Waimakariri District Council

Utilities and Roading Committee

Agenda

Tuesday 18 April 2023

Figure 3-1: Semi-trailer right turn tracking from Station Road

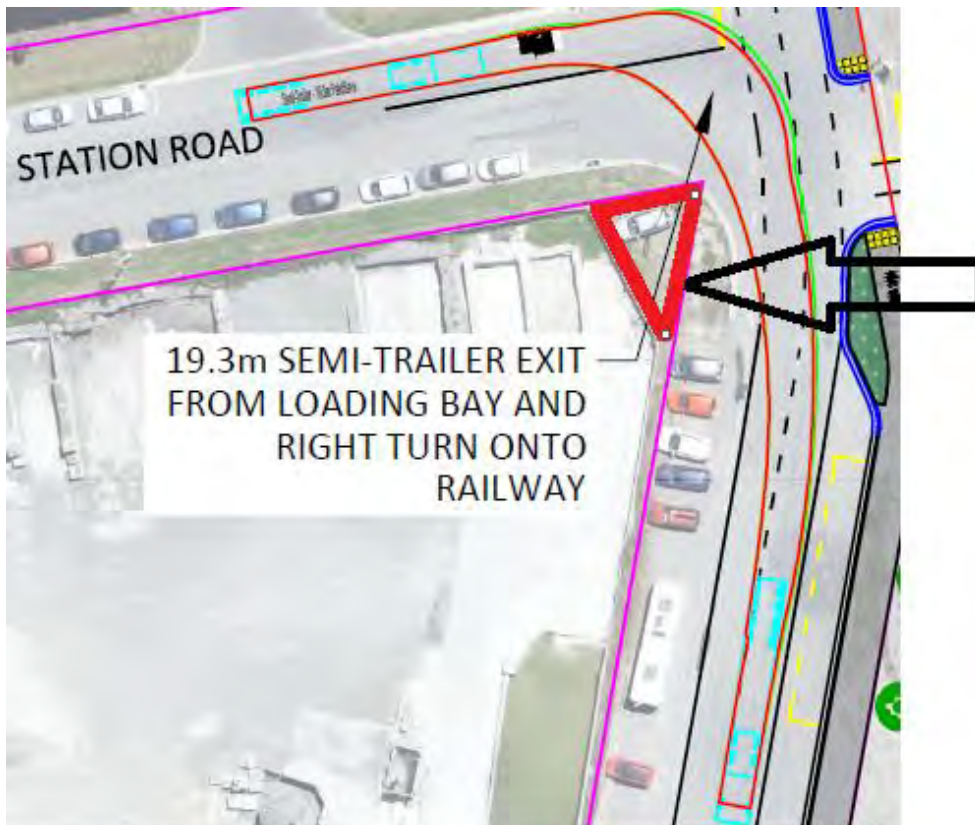
The WDC plan shows indicative tracking for a semi-trailer right turning from Station Road to Railway Road. Given the geometry of the intersection, proposed shared path and size of a semi-trailer, the tracking as shown requires some 40 to 50m for the body of the semi-trailer to clear the opposing northbound traffic lane. The reviewer considers the following should be reviewed:

- start the tracking from the Pak'nSave development left turn out to ensure the position at the intersection (for the right turn) reflects that which would be expected by Pak'nSave semi-trailers.
- confirm if an appropriate sightline can be established from the Station Road driver position; both for HCV and light vehicle; especially given the roadside car parking that could block sightlines (especially if a high sided van parked there).
- consideration of time taken for the body of the semi-trailer to clear the opposing (northbound) traffic lane and how this relates to the sightline, stopping sight distance and how drivers might respond to a HCV being on "their side of the road"

Figure 3-3: WSP concept to reconfigure priority of intersection Station Road/ Railway Road

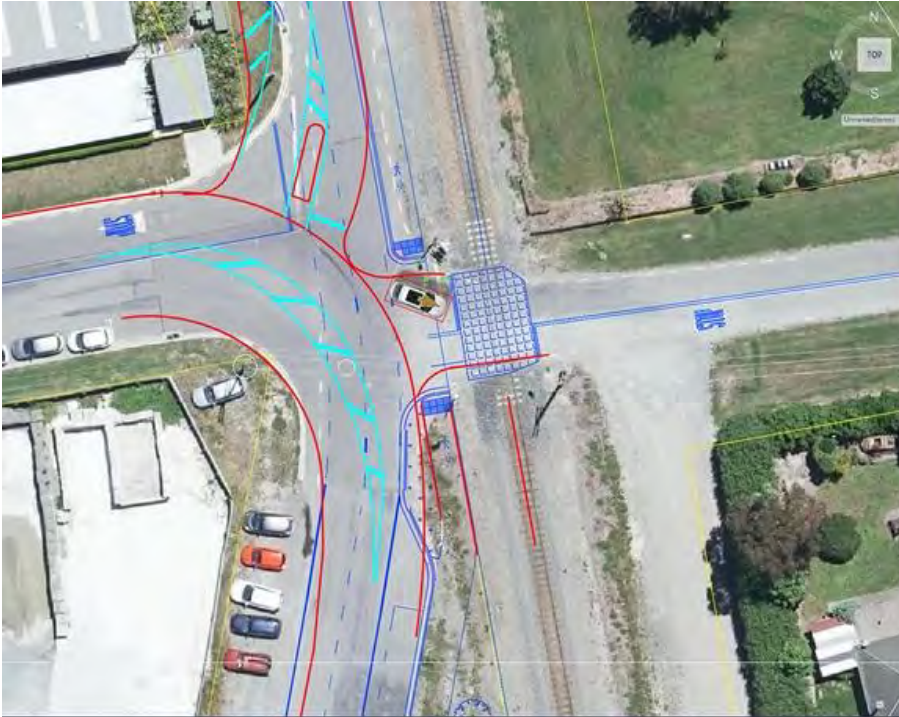
We have carried out some preliminary tracking and estimate it would take in the order of 18 seconds for a semi-trailer to clear the opposing northbound traffic lane. This time and distance to clear the opposing lane means the requirements for sightline and stopping sight distance or safe intersection sight distance (allows northbound driver 3s observation time of truck turning) are reasonably onerous.

As a potential mitigation we have considered at a conceptual level the option of altering the priority at the intersection as shown below. Amore detailed design would establish if any land purchase is required.

Figure 3-4 Station Road (LT out tracking)

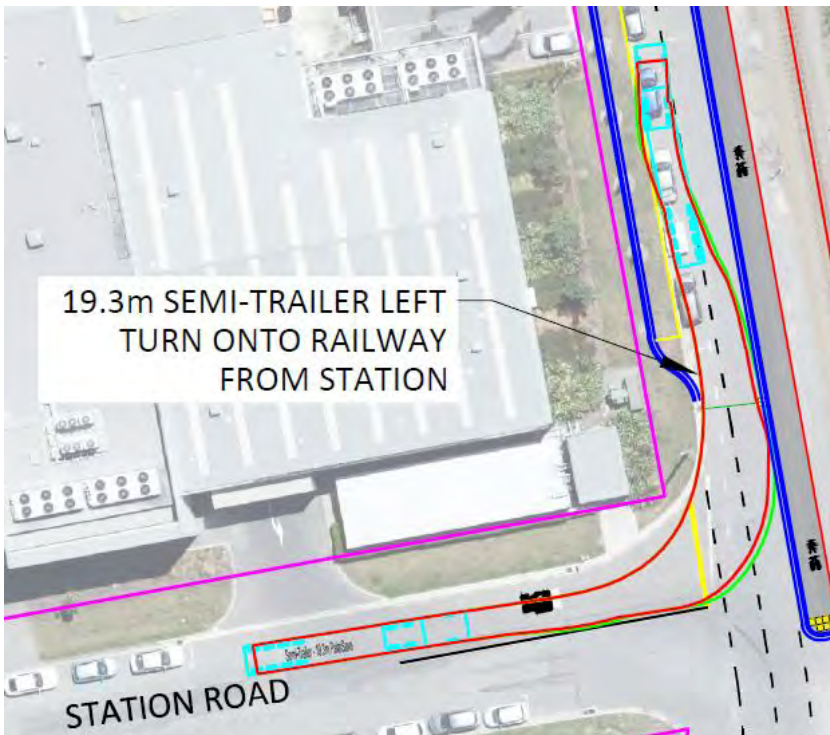
With the shared path being adjacent to the rail corridor KiwiRail may require a fence along the boundary (5m from rail); which will create a shy zone. Shy zones will also often exist where shared paths are adjacent opposing traffic lanes. The effect of this is that users may tend to use the central area of the shared path more often and move more to the outer edges when passing (same direction or opposing, pedestrian or cyclist). The length of shared path between Station Road and the proposed raised safety platform (with pedestrian crossing facility) is about 80m. WDC advised traffic volumes on Railway Road are about 875vpd south of the Pak’nSave entrance/ exit (and 675vpd north of the Pak’nSave entrance/ exit). A peak hour traffic volume of say 15%, split 50/50 north/ south would see about 65 vph each way or about 1 vehicle every minute adjacent the shared. A cyclist travelling about 15kph will travel the 80m in about 20 seconds. The proposed raised safety

platform (with pedestrian crossing facility) will moderate speed to around 30kph in that area and reconfiguring the intersection at Railway Road/ Station Road will moderate speed there as well. Considering the above points, the shared path should adequately provide for users in this relatively low speed, low volume environment.

Figure 3-6: WDC plan Pak'nSave on-street parking

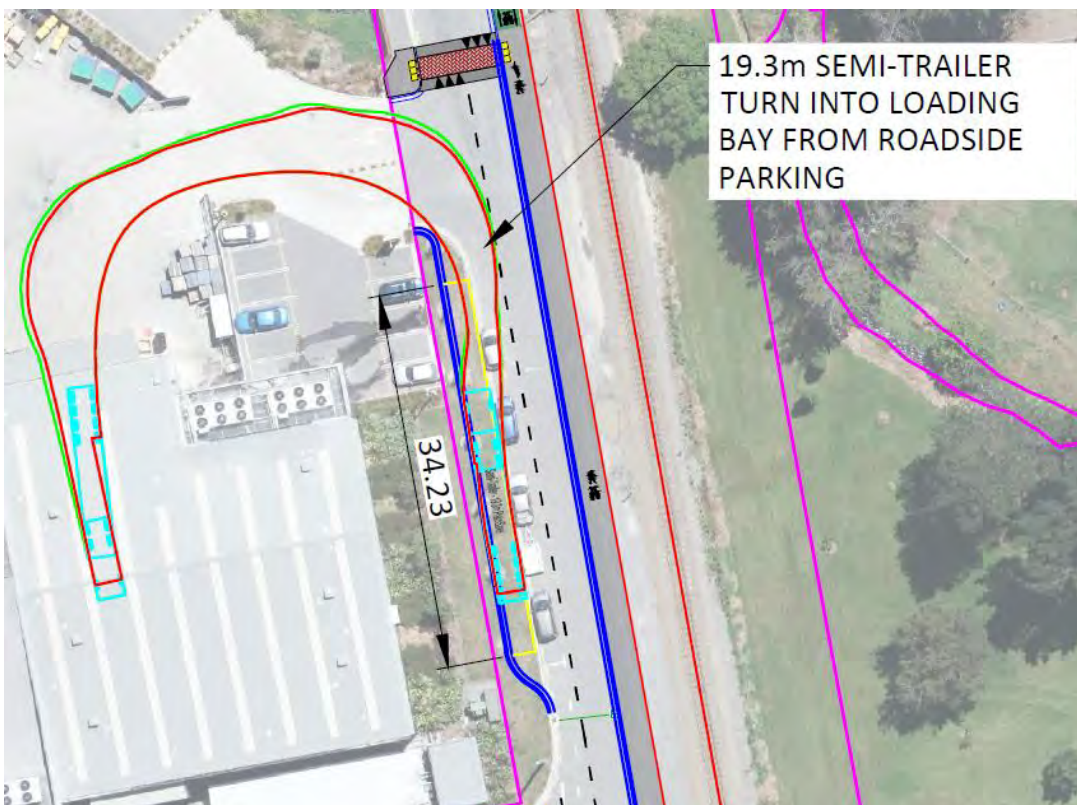
Given the redistribution of road space brought about by the proposed shared path, a check should be made of the tracking of Semi-trailer HCV into the on-street parking provided for Pak'nSave operators to ensure the HCV is aligned parallel to the kerb without the right rear protruding into the proposed northbound traffic lane. Furthermore, a check of left turn tracking into the Pak'nSave development from the "head" of the on-street parking space should be made.

If the right rear of a HCV protruded into the traffic lane this could affect safety for northbound users and potentially reduce the sightline (to establish HCV left turn over centreline or right turn) for traffic exiting Station Road.

Figure 3-7: WSP query whether semi-trailer can park parallel to kerb without encroaching traffic lane

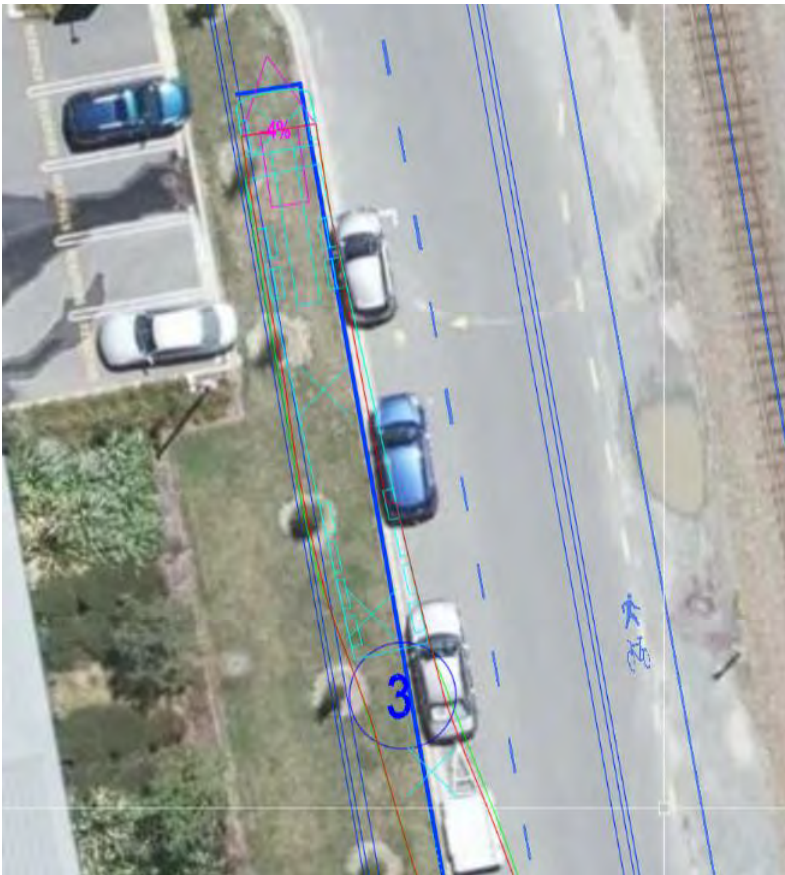
The safety issue identified above should be able to be adequately mitigated by confirming:

- The tracking of HCV into the on-street parking area (based on proposed widths; outlined earlier in report) and any overhang of right rear of HCV into traffic lane

Figure 3-12: Recreational vehicle effluent disposal site - proposed

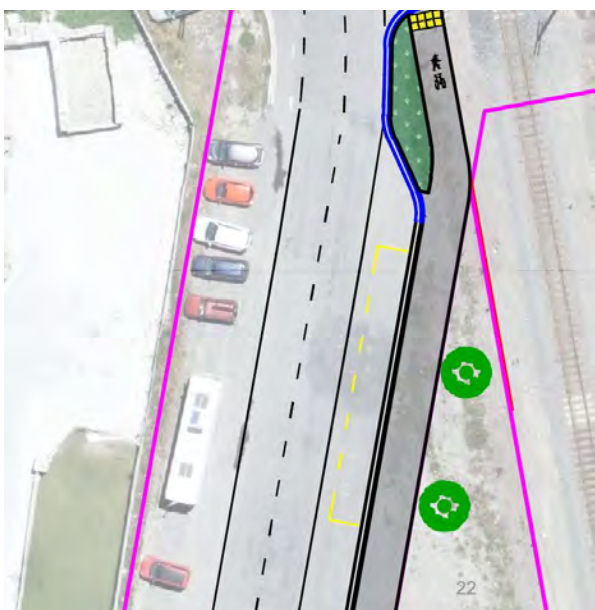
Of note, other parts of this report have considered an alternative intersection layout that will require careful design to integrate the Recreational Vehicle Effluent Disposal site and adjacent shared path. This can only be clarified through detailed design.
